Application No.: 10/733,561  
Amendments dated December 10, 2003  
Supplemental Preliminary Amendment

### **Amendments to the Drawings**

ANNOTATED MARKED-UP DRAWINGS

Fig. 2

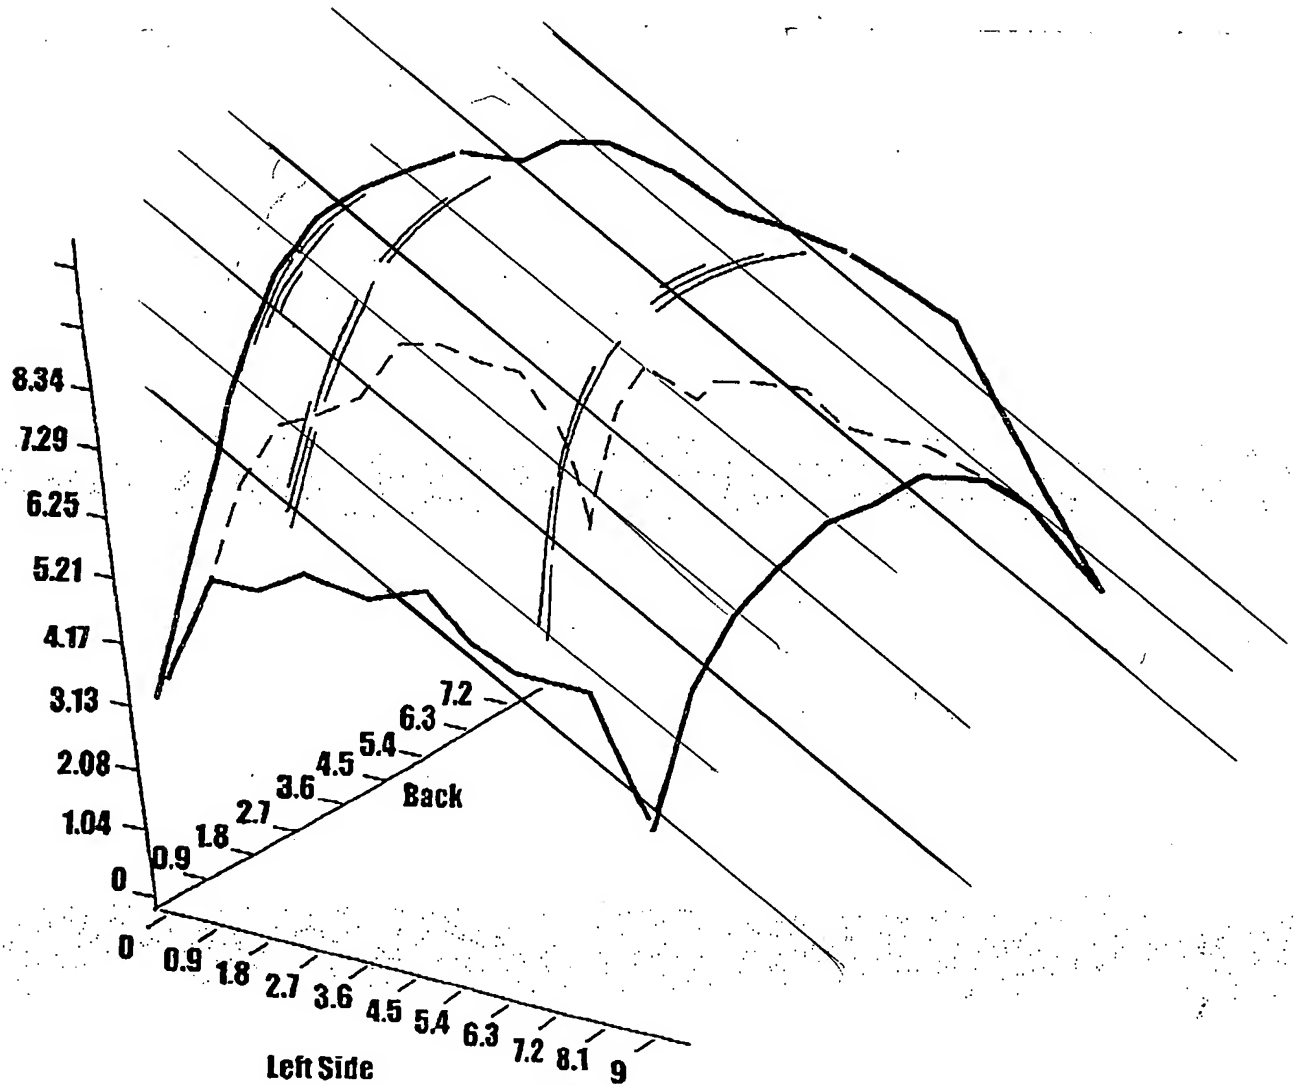
Figure 2 of the 2<sup>nd</sup> sheet (of 8) informal drawings is *replaced* by Figure 2 of the 2<sup>nd</sup> sheet of 7 of the Formal Drawings. X, Y, and Z, for the three-dimensional X, Y and Z coordinate axes of Figure 2 *omitted* from informal Figure 2, are **added**

to Formal Figure 2.

Fig. 3

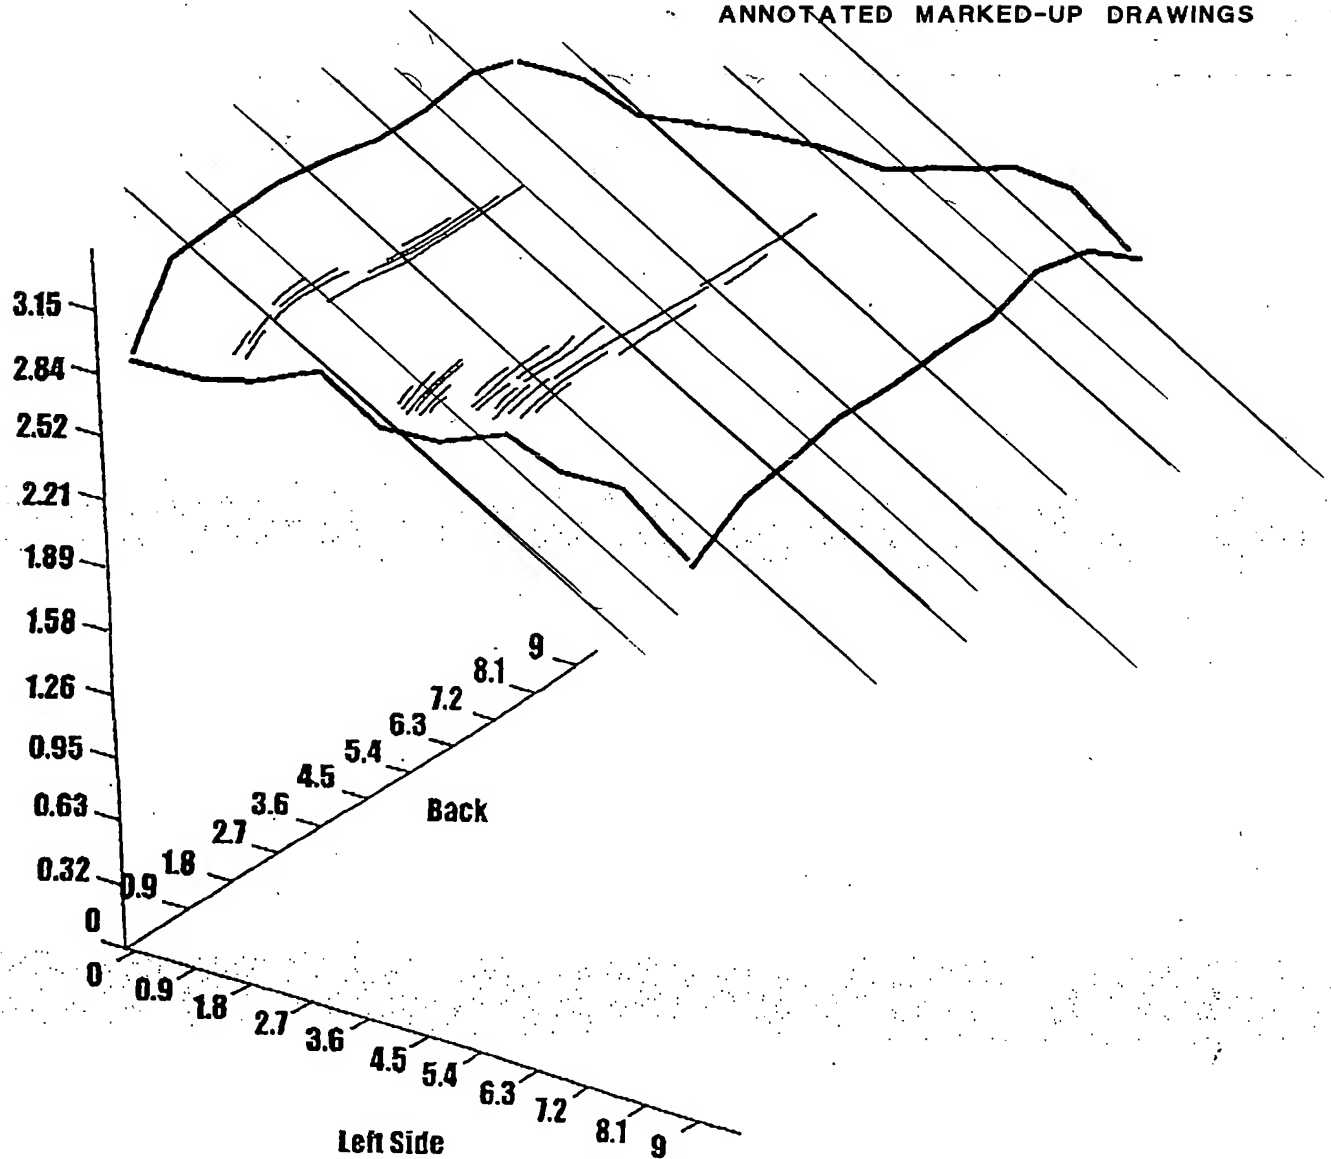
Figure 3 of the 3<sup>rd</sup> sheet of informal drawings is *replaced* by Figure 3 on the 3<sup>rd</sup> sheet of Formal Drawings. As with Formal Figure 2, X, Y, and Z for three-dimensional X, Y and Z coordinate axes of Figure 3 *omitted* from informal Figure 3 are **added** to Formal Figure 3.

Fig. 4

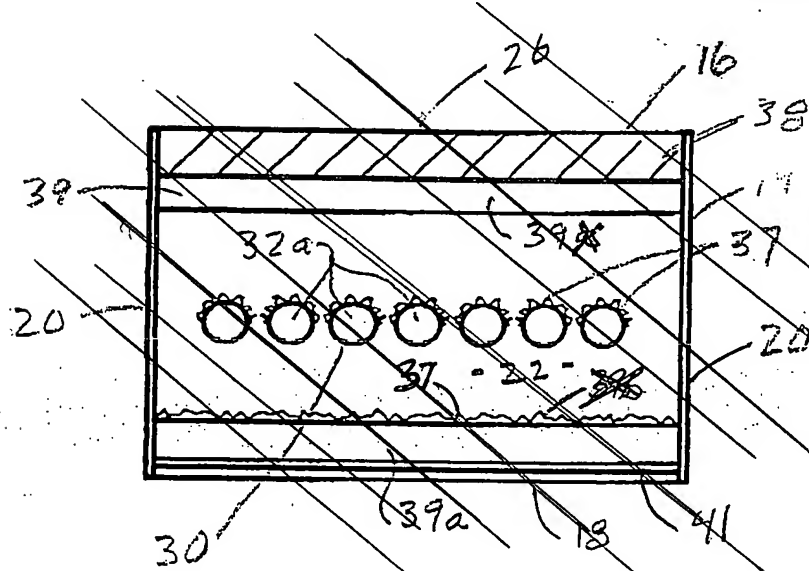
Figures 4, 5, and 4A of the first and second '4 of 7' sheets of informal drawings are replaced by Formal Figures 4, 5, and 4A of the 4<sup>th</sup> sheet of Formal drawings. Element 39a of informal Figure 4 is **changed** to 39 in Formal Figure 4, and element 39b of informal Figure 4 is **changed** to 37 of Formal Figure 4.
